RESPONSE LETTER

Manuscript Number: egusphere-2026-1378

Title: Managed Aquifer Recharge in Confined Multi-Layer Aquifers: A Scalable Framework for Drought Resilience in Central Europe

Response to the Reviewer #1:

Table S2. Lag-correlation analysis for SPEI-1, SPEI-3, SPEI-6, and SPEI-12 vs SGI

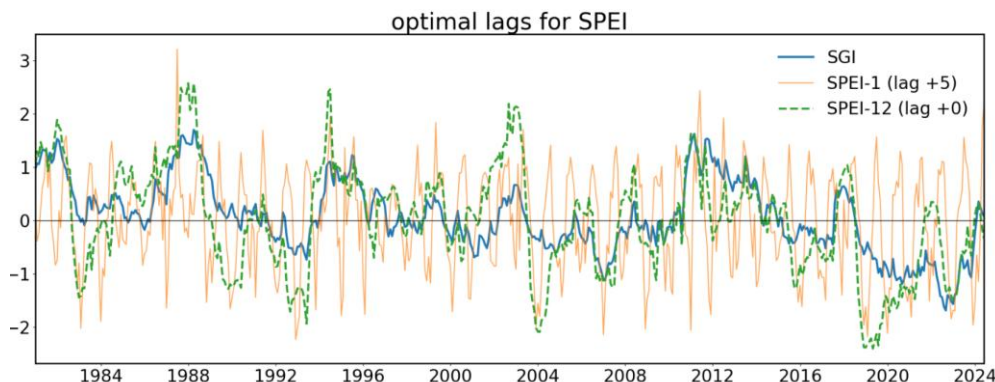
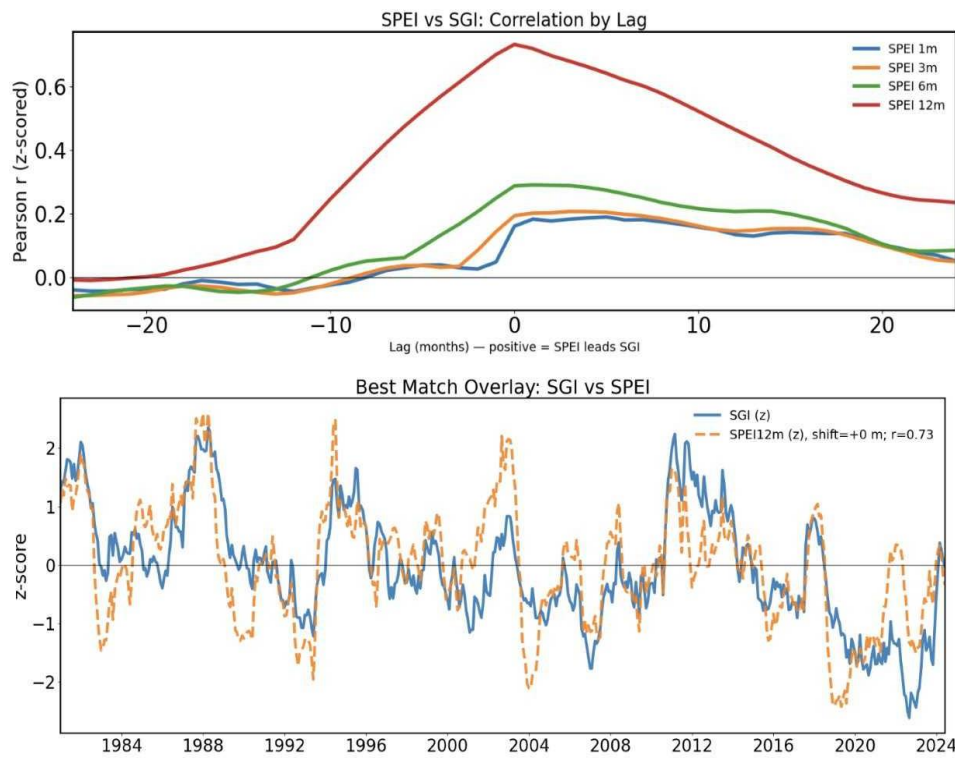
1) The authors report a high pearson correlation between SPEI-12 and SGI with "no lag". This is an interesting finding for a confined multi-layer aquifer system, where pressure propagation rather than direct recharge drives head changes. The manuscript does not sufficiently explain the hydrogeological mechanism behind this near-instantaneous coupling. In confined systems, piezometric responses can be rapid, but this is a different mechanism than moisture storage response observed in unconfined systems. This distinction must be clearly discussed and reconciled with the literature.

It would be more correct, rather to state that the absence of lag between SPEI 12 and SGI "indicates that groundwater levels in this confined aquifer respond almost immediately to climatic anomalies" (Discussion section, lines 487-488) to state that the time scale of the response process of groundwater levels to climatic anomalies is not detectable by the aggregated annual scale of SPEI 12 compared with SGI.

Due to the importance of this statement in discussion and conclusion section, to avoid misinterpreting of results and findings, a montly based analisys using SPEI 1 would be recommended to eventually detect and quantify lags or strongly confirm the "immediate response of GW to climate variability" statements of the whole manuscript.

We thank the reviewer for this important and constructive comment. We agree that the previous wording could be misinterpreted. We have changed the wording to avoid misinterpretation, clarifying that the absence of a detectable lag at the SPEI-12 scale does not demonstrate an immediate physical recharge response. Rather, it indicates that the response time of groundwater levels to climatic anomalies is not resolved by the 12-month accumulated SPEI timescale. Because SPEI-12 already integrates the climatic water balance over the preceding year, a zero-lag correlation means that SGI co-varies with annual-scale climatic anomalies, not that groundwater storage responds instantaneously.

Following the reviewer's suggestion, we performed a monthly lag-correlation analysis using SPEI-1, SPEI-3, SPEI-6, and SPEI-12 against SGI for lags of 0–24 months. The SPEI-1 analysis showed only weak correlations with SGI ($r = 0.108$ at 3-month lag), whereas correlations increased for longer accumulation periods and were strongest for SPEI-12 at zero lag ($r = 0.632$, $r^2 = 0.40$). This supports the interpretation that the groundwater system primarily reflects accumulated climatic anomalies over multi-month to annual timescales rather than individual monthly anomalies (please see new Table S2 in Supplementary Materials).

We have also added a hydrogeological explanation specific to the confined aquifer setting. In this system, SGI represents piezometric head variations. These may respond rapidly to pressure propagation and changes in boundary conditions, but this mechanism differs from direct recharge or soil-moisture storage responses typical of unconfined aquifers. We therefore revised the Discussion and Conclusion to distinguish between piezometric response and direct groundwater recharge/storage response.

Figure 4. Methodological flowchart illustrating the sequential structure of the integrated ASTR feasibility assessment framework, from data processing and analytical components to final suitability and economic outputs.

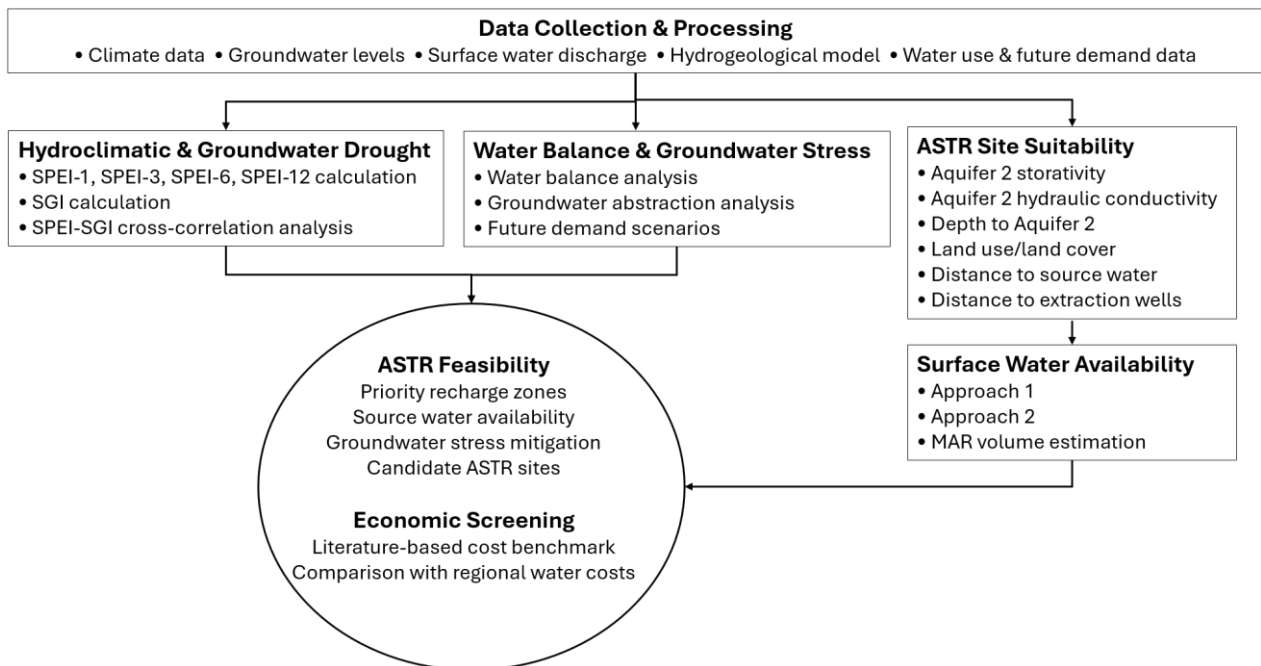
3) Globally, a flowchart image of the methodology would enrich methodological section.

We thank the reviewer for this valuable suggestion. We agree that a flowchart significantly improves the clarity of our complex methodology. We have added a comprehensive methodological flowchart (Fig. 4) that illustrates the sequential structure of our framework, starting from data processing, through the four main analytical components (drought assessment, water balance, GIS-MCDA, and flow-threshold analysis), culminating in the final ASTR suitability and economic outputs. A reference to this figure has been added to Section 3.

The overall structure and sequential progression of the methodological framework are illustrated in the flowchart (Fig. 4), which integrates hydroclimatic drought assessment, GIS-MCDA site suitability, surface water availability, and economic screening.

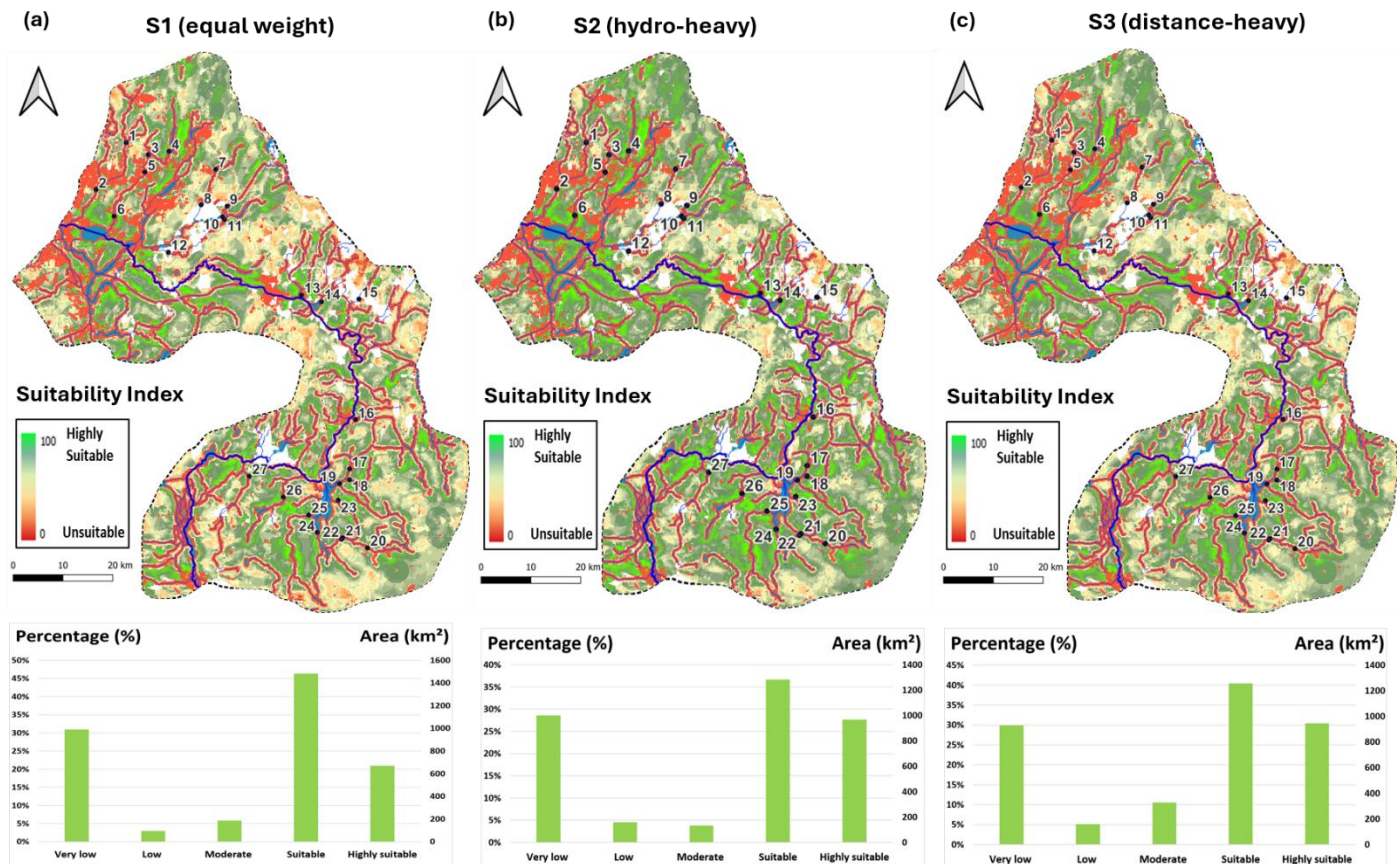
4) In section 3.4, regarding the MCDA procedure for selecting site suitabilities for ASTR and MAR, you selected six site-selection criteria and classify their suitability scores. MCDA applications in groundwater related Issues, such as groundwater potential recharge evaluation and mapping, are very common in scientific literature of recent Years; often exploring and selecting different ranges of criteria due to case specific needs or constraints. In your case, criteria selection seems to be arbitrary or author-knowledge based, as well as the attributed scores in table 1 and their range values, which can be acceptable only if properly justified for the characteristics of your case study and strongly linked to scientific literature and to the purpose of your study. In any case, your choices have to be properly framed in the context of contemporary scientific literature on the topic. From both aspects, this methodological section of the manuscript is weak and needs improvements.

5) Moreover, regarding MCDA procedure, you apply equal weighting to all six MCDA criteria. It is well-known that weighting choices strongly influence MCDA outcomes in MAR suitability studies. The manuscript acknowledges this only in passing ("based on literature and expert judgment"). A sensitivity analysis testing alternative weighting schemes is strongly recommended.

To address concerns about arbitrary weighting, we performed a sensitivity analysis using three distinct weighting scenarios (equal weight, hydro-heavy, and distance-heavy). Results demonstrate high robustness: the "Very Low" suitability class remained stable at ~29% across all scenarios (variation <0.3%), and high-suitability zones stayed in the same geographic locations. This confirms that identified priority zones are controlled by actual physical constraints rather than subjective weight assignments (Hani et al., 2023; Vandala and Mahed, 2025). We have updated Sections 3.4 and 4.3, added Tables 2–3, and revised Figure 6 to present these findings.

Sensitivity Analysis Results: We tested three weighting scenarios (Table 2). Results demonstrate high robustness (Fig. 6; Table 3). The "Very Low" suitability class remained stable at ~29% across all scenarios (variation <0.3%), indicating physical constraints consistently define unsuitable areas. The "Suitable" class showed moderate variation (36.7-43.3%; $\Delta = 6.6\%$), while "Highly Suitable" areas varied between 17.2% (S3) and 27.7% (S2) ($\Delta = 10.5\%$).

Despite percentage variations, the spatial distribution of high-suitability zones remained geographically consistent across all scenarios (Fig. 6a-c), confirming that site suitability is primarily controlled by underlying physical characteristics rather than subjective weight assignment (Hani et al., 2023; Vandala and Mahed, 2025).

Updated Figure 6

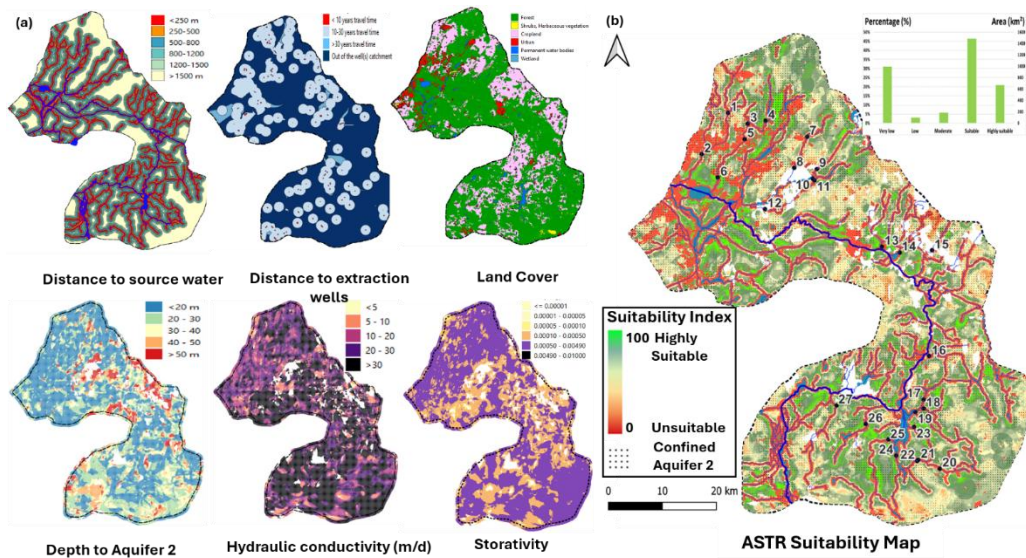
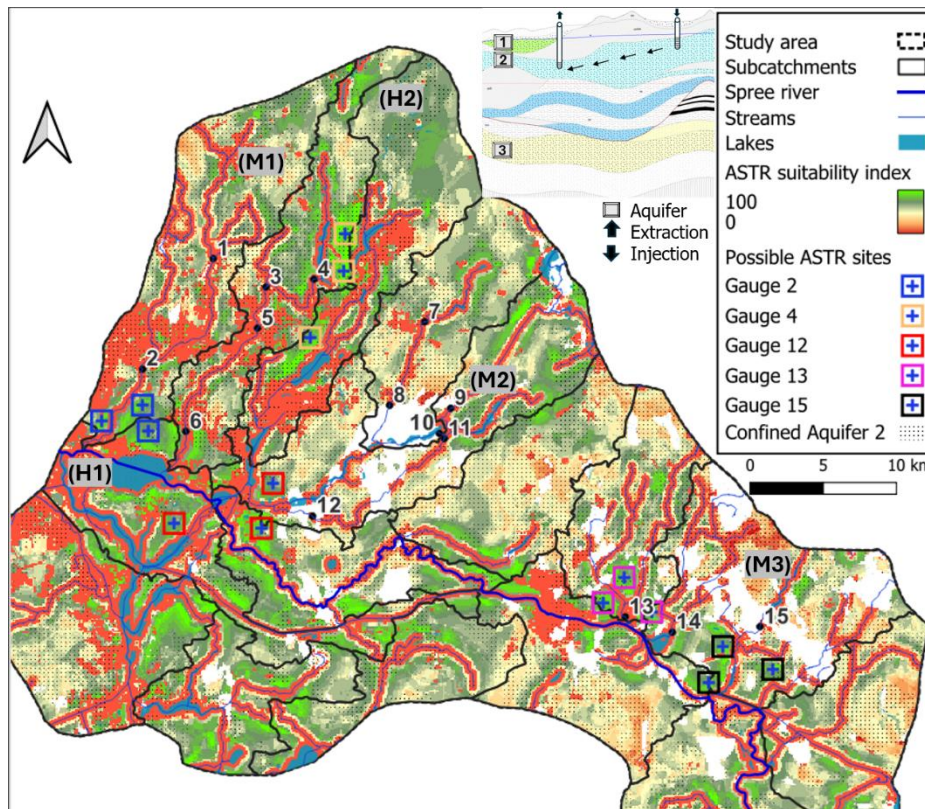
There is one main aspect that requires some more attention by the authors: they claim that their technique applies to confined aquifer systems such as Aquifer 2. In Chapter 3.4 they present the different criteria applied for the ASTR suitability assessment (L239 onwards). One criteria is storativity, a critical property within the context of MAR, especially if the aquifer system is confined, implying feasibility or efficiency of MAR measures. I do recommend that the areas with the aquifer 2 being confined to be outlined in Figure 6f and figure 10.

Should artificial recharge be accomplished via the unconfined Aquifer 1 and aquifer 2 be recharged via hydraulic windows, then, different criteria need to be selected on top. In order to clarify the concept for the reader, I recommend to the authors that they present a schematic diagram for different ASTR settings to demonstrate the feasibility of substantial volumes of storage, as well as the expansion of the suitability criteria. (schematic diagram in the Updated Figure 10)

We thank the reviewer for this valuable suggestion. We have updated Figure 6 and Figure 10 to explicitly outline the areas where Aquifer 2 is confined (indicated by the dotted pattern in the legend). Furthermore, we have added a schematic diagram in the top-right corner of Figure 10 to illustrate the ASTR process, demonstrating direct injection into and recovery from the confined Aquifer 2. These visual additions clarify the feasibility of substantial storage volumes and the rationale behind our suitability criteria.

We thank the reviewer for raising this important conceptual point. As clarified in the updated schematic diagram (Figure 10), our framework specifically evaluates direct injection and recovery within the confined Aquifer 2. Because the study focuses on this direct pathway, the current suitability criteria (e.g., Aquifer 2 storativity and hydraulic conductivity) are fully appropriate. We have added a clarifying sentence in Section 3.4 to explicitly distinguish the evaluated direct ASTR setting from the indirect pathway via Aquifer 1, explaining why the criteria were not expanded to cover the latter.

To clarify the conceptual framework for the reader, the schematic diagram in Figure 10 illustrates that this study specifically evaluates direct injection and recovery within the confined Aquifer 2. While indirect recharge via the unconfined Aquifer 1 and subsequent leakage through hydraulic windows represents an alternative ASTR setting, it requires distinct hydrogeological criteria and is therefore excluded from the current suitability assessment.

Updated figure 5c

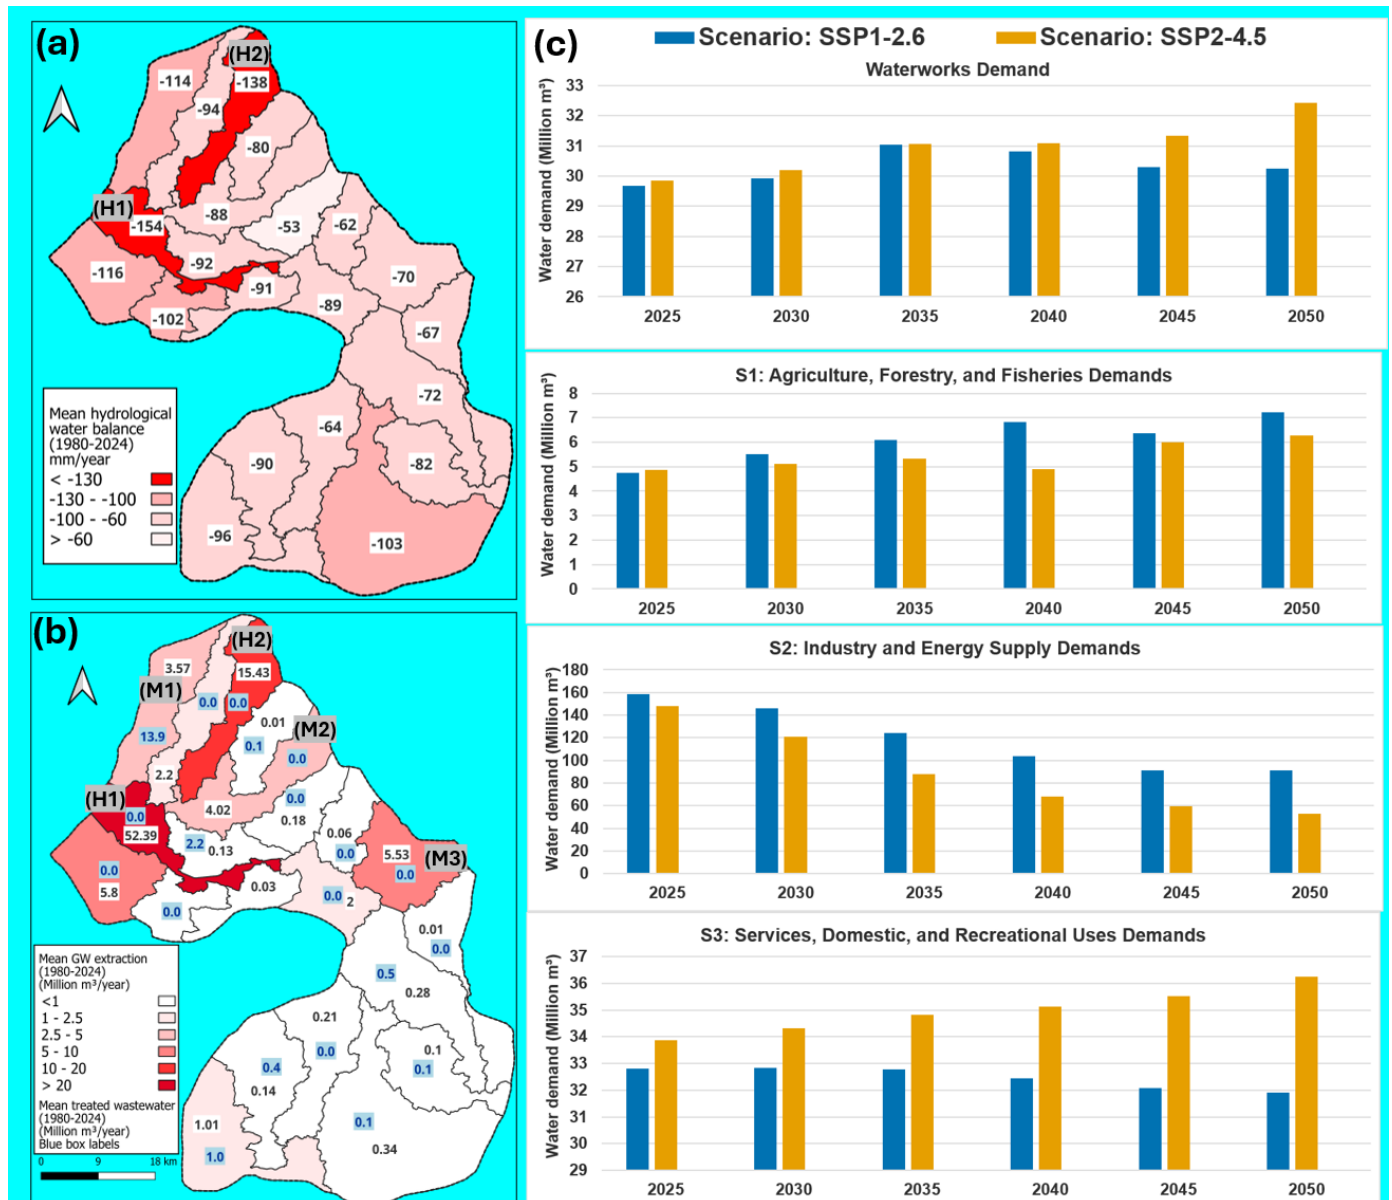
L227: RCP8.5 is highly unlikely; needs a statement, why it is considered here.

We thank the reviewer for raising this important point. We acknowledge that the reference to RCP8.5 was incorrect. In this study, we do not use RCP-based results; instead, we consider socio-economic development pathways based on the SSP framework (specifically SSP1-2.6 and SSP2-4.5), consistent with IPCC AR6. We have entirely removed RCP8.5 from all calculations, figures, and text in the manuscript. To address the specific points raised:

Projections were developed using SSP pathways (SSP1-2.6 and SSP2-4.5), consistent with IPCC AR6 and UBA regional climate projections (Kreienkamp et al., 2022). These pathways represent different socio-economic trajectories and were linked to sector-specific water demand projections from local stakeholders (BWB, Adelphi Research, ZALF). Climate variables were bias-corrected and calibrated against historical meteorological and hydrological records within the SWIM model to ensure reliable water-balance estimates.

We analysed projected water-demand scenarios for 2025-2050 and found a moderate but steady increase in total waterworks demand across the considered scenarios (Fig. 5c). Under SSP1-2.6, total waterworks demand fluctuates around 30-31 Mm³, while the most-likely SSP2-4.5 scenario shows a modest increase from ~30 to ~32 Mm³ by 2050. This spread (~1-2 Mm³) defines the stress-test range for storage and recovery capacity under realistic future conditions.
